APPLICATION NO.	FILING DATE	FIRST NAMED INVENTOR	ATTORNEY DOCKET NO.	CONFIRMATION NO.
10/706,410	11/12/2003	Jerry Joe Wolfe JR.	102-1189	6794

Office Action Summary

DETAILED ACTION

**FIG. 4**

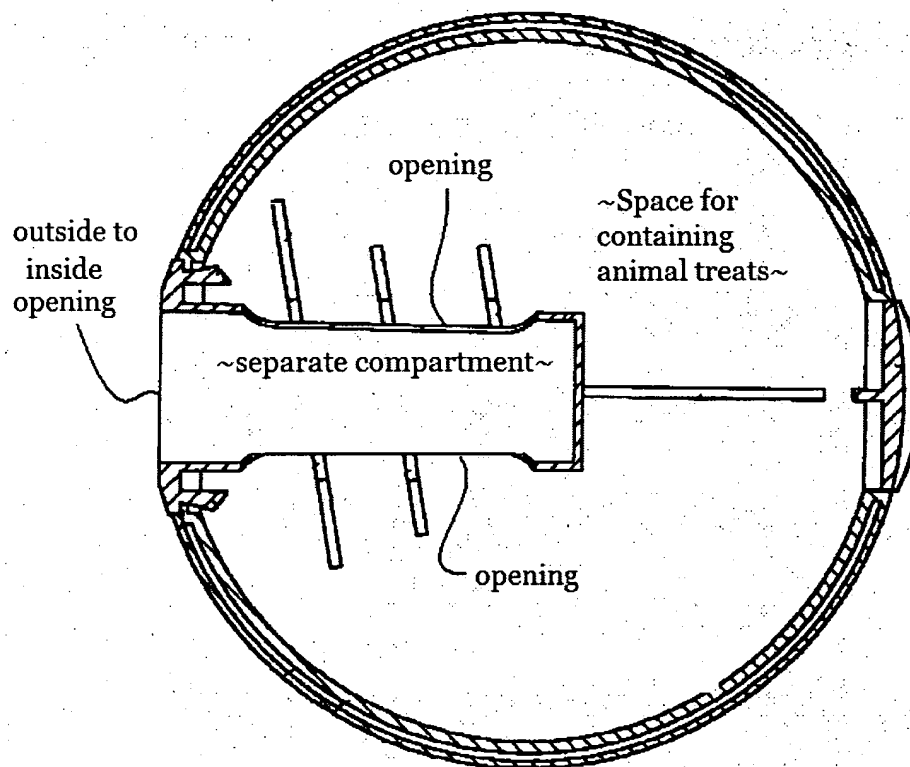
Wang discloses a ball (3) with an outside and an inside, the inside including space for containing animal treats and a separate compartment wherein the separate compartment also includes at least one space for containing animal treats and two openings in the separate compartment and at least one opening from the outside to the inside of the ball (reference detailed Figure 4 below).

Regarding claim 16, Wang discloses the separate compartment is offset from a center location of the ball (reference Figure above showing the separate compartment offset to the left of center).

Regarding claim 17, Wang discloses the two openings in the separate compartment include a funnel section for funneling items into the at least one opening

(reference the above figure showing the opening narrowing into the separate compartment thereby defining a funnel).
